Subject: 2004-2009 MAZDA3 (5-DOOR) - HAZY REAR COMBINATION LAMP LENS	M-Tips No.: MT-013/17
	Last Issued: 07/06/2017

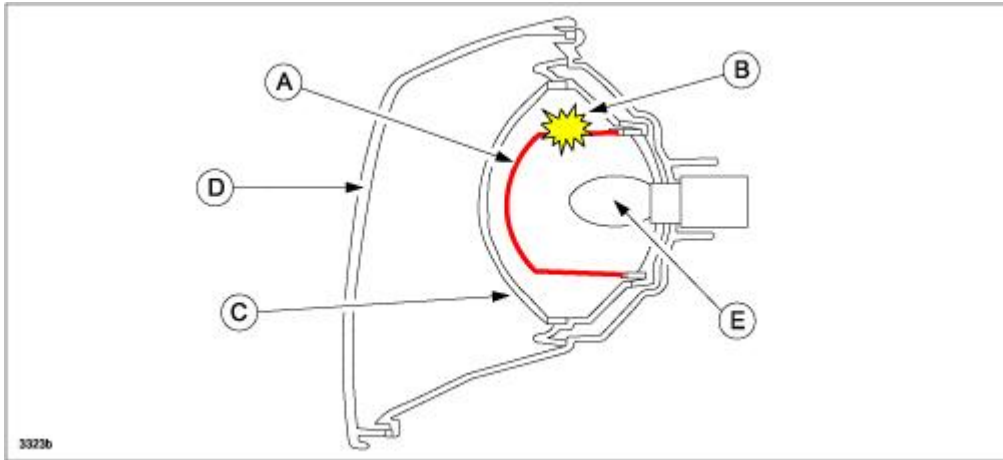
Due to heat accumulated by extended brake light (E) usage, the red inner cap(A) is melted (B) and the inner (C) and/or outer (D) lens becomes hazy.
